In the Matter of
LONG ISLAND LIGHTING COMPANY
(Shoreham Nuclear Power Plant,
Unit 1).

SUFFOLK COUNTY'S EXHIBITS TO JOINT DIRECT TESTIMONY

CRANKSHAFT EXHIBITS
40-50
VOLUME 2

INDEX TO THE ATTACHMENTS AND EXHIBITS TO THE
JOINT DIRECT TESTIMONY OF DR. ROBERT N. ANDERSON,
PROFESSOR STANLEY G. CHRISTENSEN, G. DENNIS ELEY,
DALE G. BRIDENBAUGH AND RICHARD B. HUBBARD REGARDING
SUFFOLK COUNTY'S EMERGENCY DIESEL GENERATOR CONTENTIONS

FIG. 1

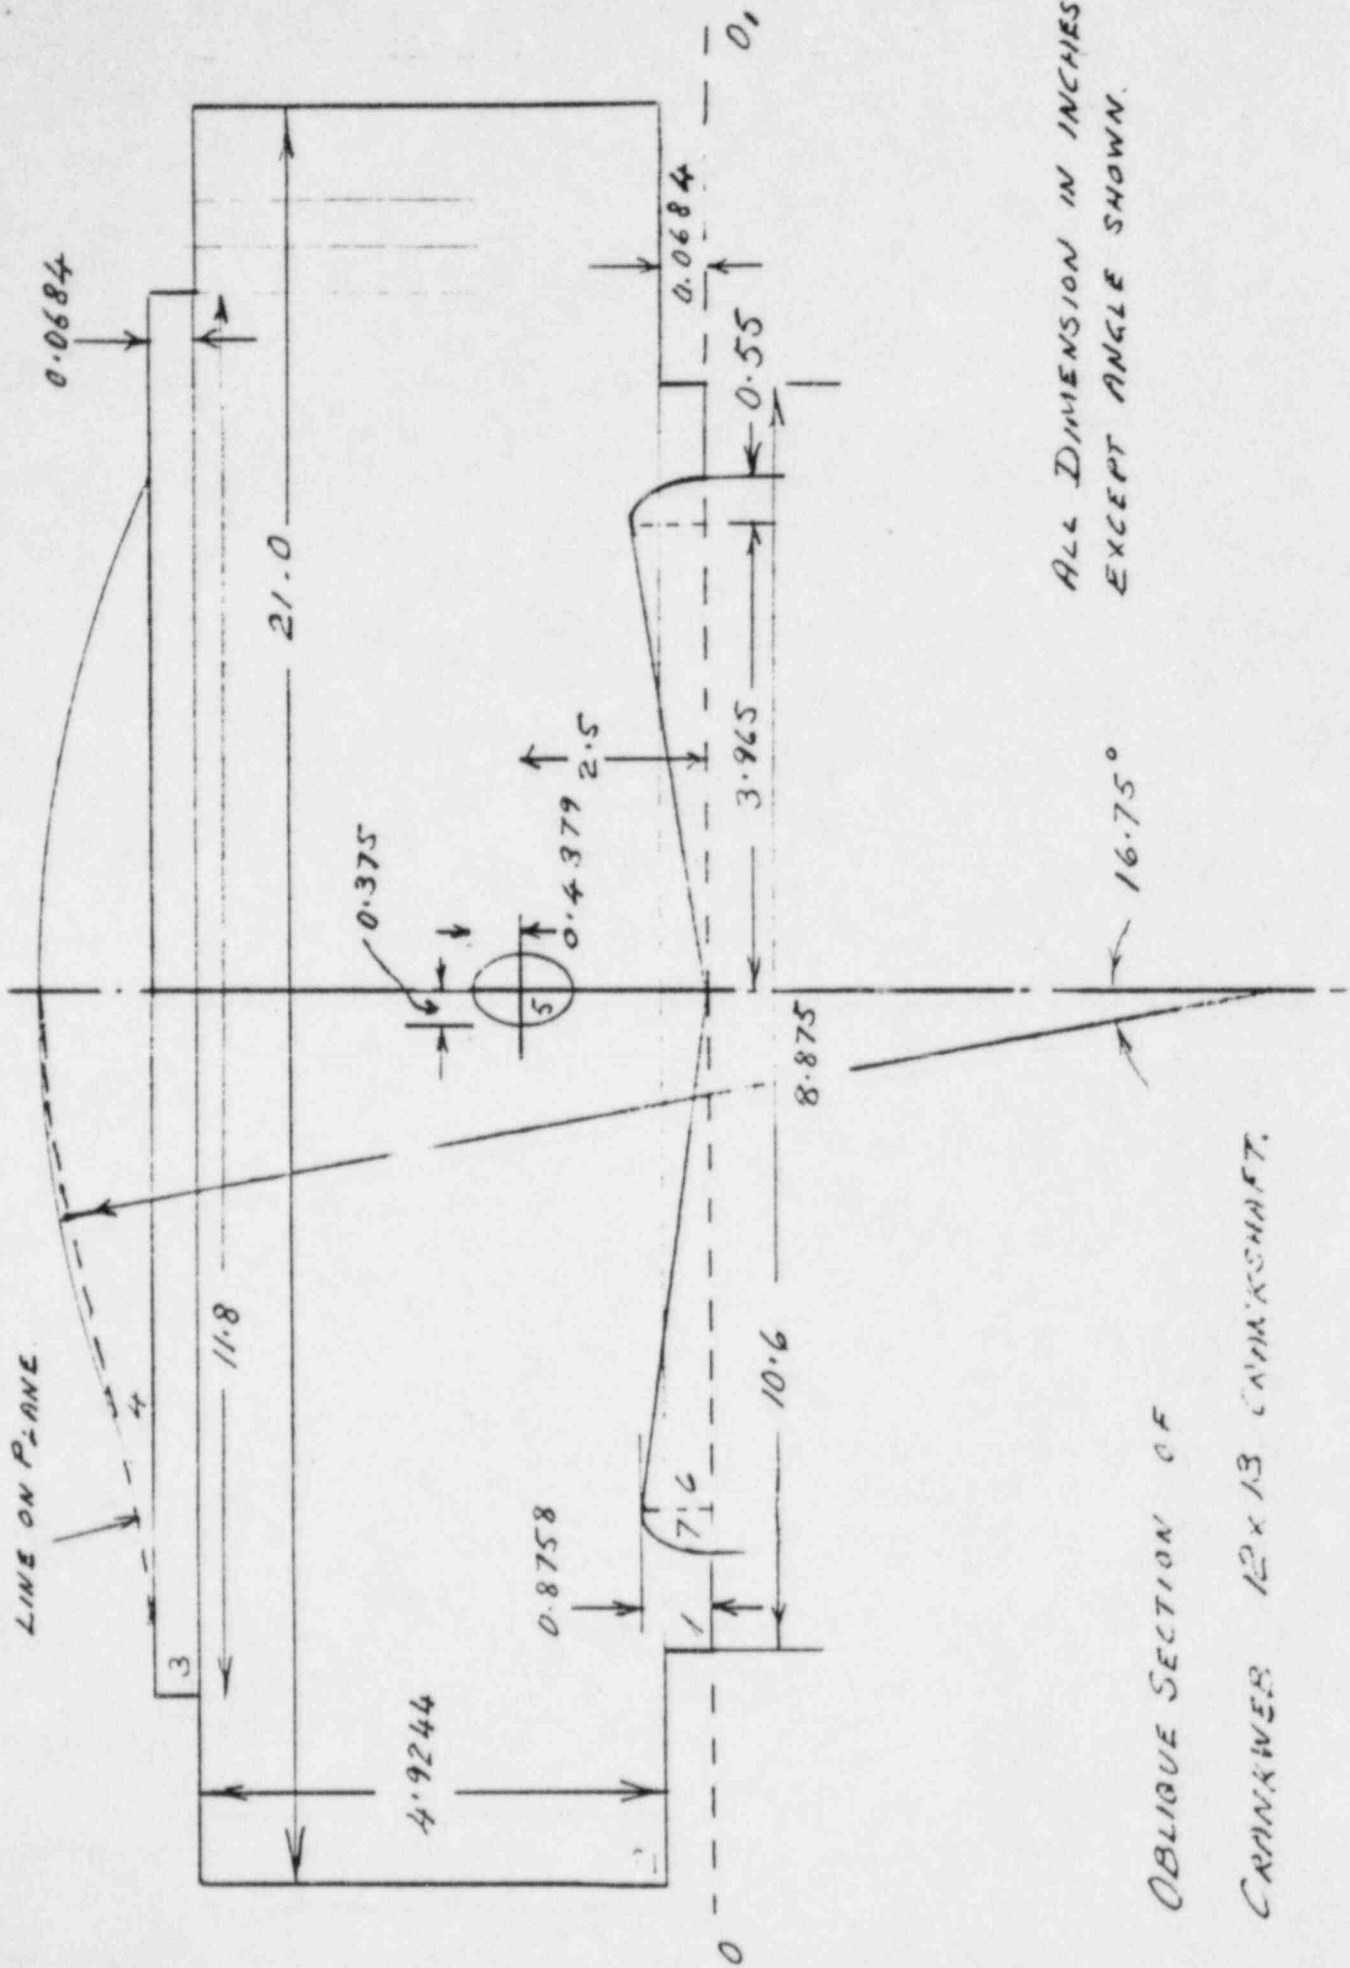
THE RE-ENTRANT FILLET ACTS AS A SERIOUS STRESS RAISER WHEN CONSIDERING THE OBLIQUE SECTION OF THE WEB UNDER THE ACTION OF BENDING. THIS HAS BEEN SHOWN TO BE TRUE IN THE SECTION OF THE WEB OF THE FRACTURED CRANKSHAFT. THE NUCLEATION SITE OCCURRED AT THE BOTTOM OF THE RE-ENTRANT FILLET.

THE EFFECTIVE MOMENT OF INERTIA OF THE SECTION ON THE OBLIQUE PLANE CAN ONLY BE OBTAINED BY SUMMATION METHOD.

THE OBLIQUE PLANE REQUIRES GEOMETRICAL DEVELOPMENT TO OBTAIN THE BOUNDARY OF THE RE-ENTRANT FILLET AND THAT PART OF THE JOURNAL FILLET CUT BY THE OBLIQUE PLANE.

THE OIL PASSAGE WILL ALSO HAVE AN EFFECT WHICH MUST BE CONSIDERED AS IT WILL BE NEGATIVE IN VALUE. THE TRUE NEGATIVE VALUE WILL BE DEPENDENT ON THE DISTANCE OF ITS CENTER FROM THE NEUTRAL AXIS.

SEE FIG. 1 FOR SKETCH OF SECTION THROUGH WEB ON OBLIQUE PLANE AT 23.9625 SAY 24° TO PIN AXIS.

FROM THIS IT IS SEEN THAT THE MOMENT OF RESISTANCE ON THE OBLIQUE SECTION IS A VERY CRITICAL FIGURE IN THE STRENGTH OF THE CRANKSHAFT.

THE STRENGTH OF THE WEB IS VERY CRITICAL WHEN RELATED TO MAXIMUM CYLINDER PRESSURE

THE CRANKSHAFTS DO NOT MEET ABS RULES FOR 4890 HP.
